Requests for information – Minor Applications

1.2 Ralph Lauren, 1 Don Street

PROJECT NAME	
BELONGIL SEAWALL REPAIRS	
DRAWING TITLE	
PLAN VIEW (PRESENT) 1 AND 2 DON STREET, BELONGIL	
DRAWING No.	REVISION:
BSR-DS-UW-002	A
DRAWN: SK	CHECKED: AJ
APPROVED: AJ	
RPEQ 2876	
SIZE: A3	SCALE: A3
DATE: 22 Jan, 2018

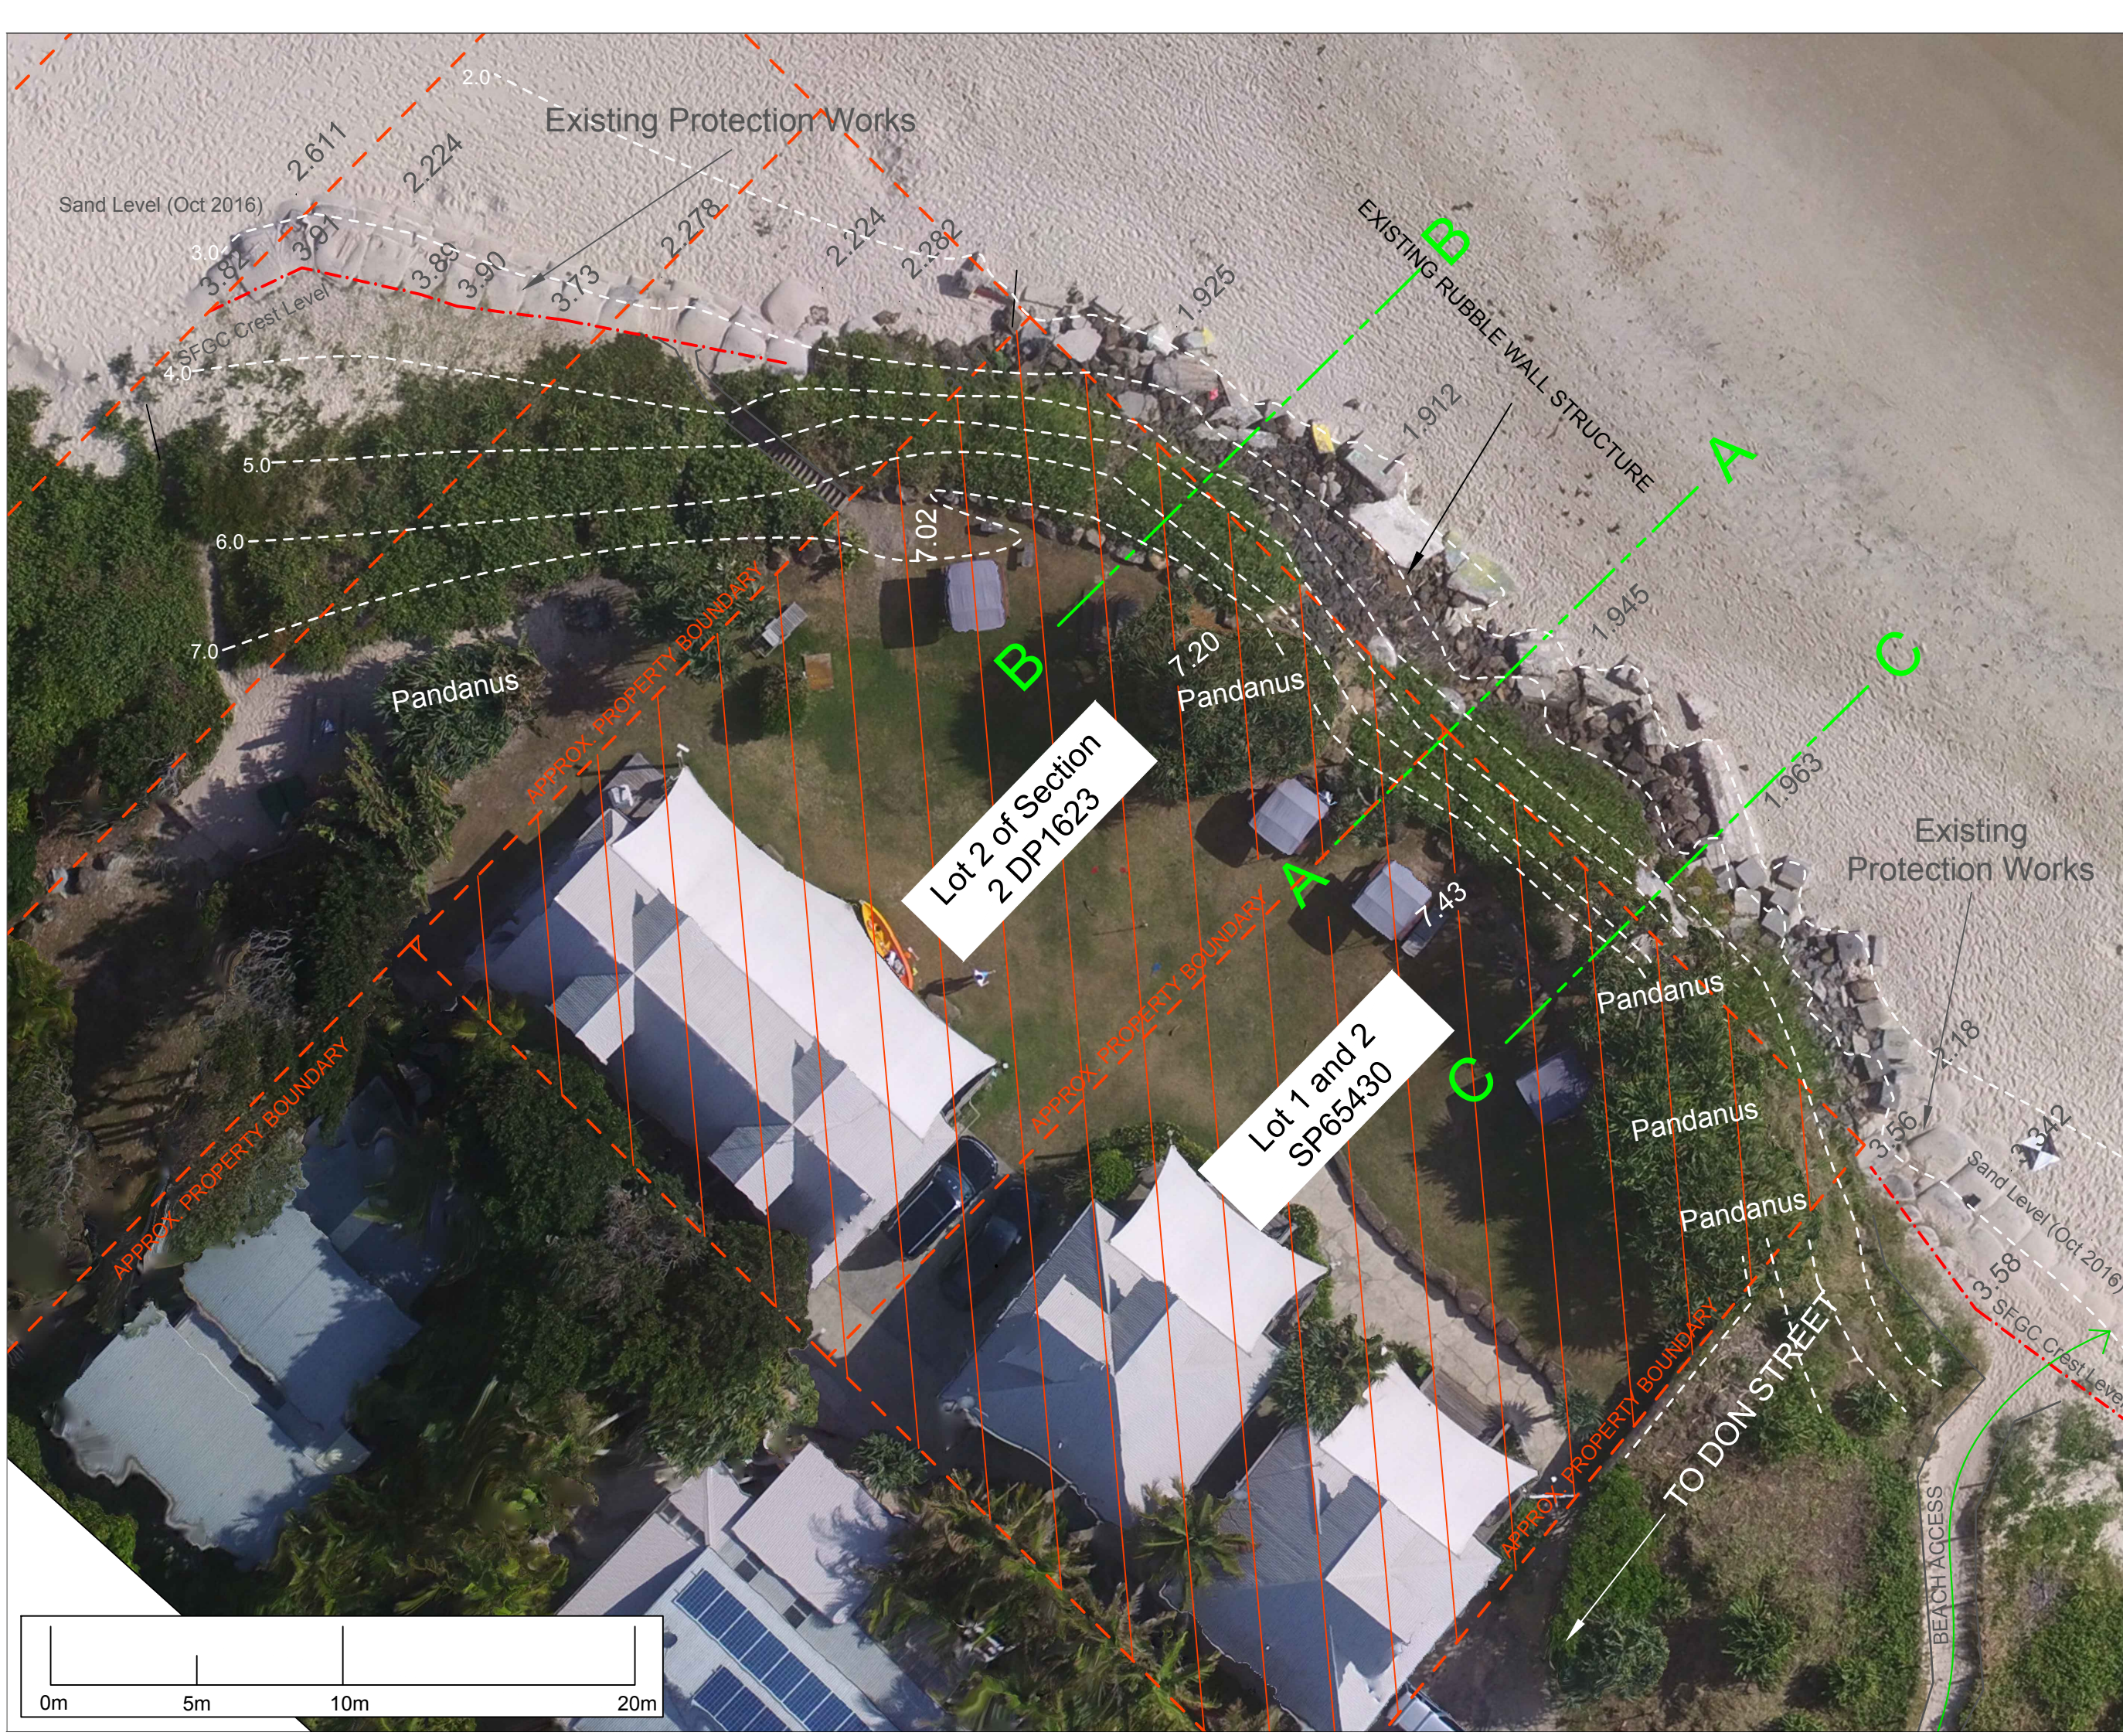
#	Request for information	Response
1.	A current survey indicating the heights of the current structure (the face of the wall "as is"), property boundaries, footprint of the proposed works and the current sand level	<p>We have already provided this information. The details requested have been provided in the technical drawings by a coastal engineer previously provided and there has been little or no change:</p> <ul style="list-style-type: none"> height of current structure and face of wall: Drawings BSR-DS-UW- 003, 005 and 007 show these details. ICM have also added contours of the visible section of the seawall face of the wall in drawing BSR-DS-UW-002 (Attachment 1.2 A) in this drawing these contours are smoothed as the wall face is very rough with 20-30% voids between large boulders. property boundaries: Drawings BSR-DS-UW- 003, 005 and 007 show the details. The seaward boundary and corners will be pegged before repairs are commenced. footprint of the proposed works: the footprint was shown in Figure 6 of the August 2017 ICM Report and drawings BSR-DS-UW-004, 006 & 008. BSR-DS-UW-005 has been revised to also show the footprint detail on this drawing (Attachment 1.2 B). existing sand level: BSR-DS-UW- 003, 005 and 007 show beach sand levels at the wall as at 13/10/16 (post June 2016 storms) and there has been accretion and an increase in sand level along the Belongil seawalls (about 0.3m in this vicinity) since that date to 17/1/18.

10.	Diagram(s) indicating the footprint of the proposed works.	Refer response to similar query in row 1 above.
